Ford and International 6.9 Diesel Engines – Mandatory Spacer

Application Ford & International 6.9 Liter Diesel engines CARDONE[™] Part 59-8304 & 59-8305

WATER PUMP MOUNTING BOLT LENGTHS & LOCATIONS

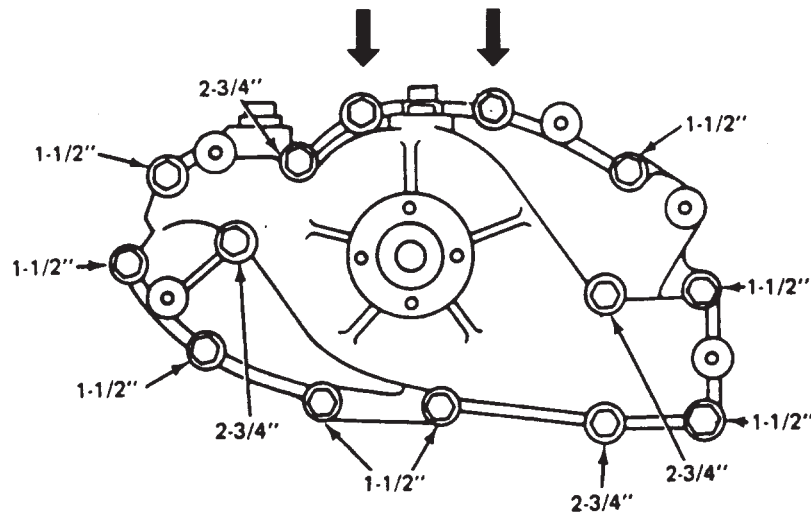
Problem If the mounting flange on the original pump is 1-1/16" thick at the top two mounting holes and if the replacement unit is 13/16" thick, you must use two 1/8" spacers or 1-1/4" bolts.

Warning IF THIS IS NOT DONE, INJECTOR PUMP FAILURE WILL OCCUR AND VOID THE WATER PUMP WARRANTY.
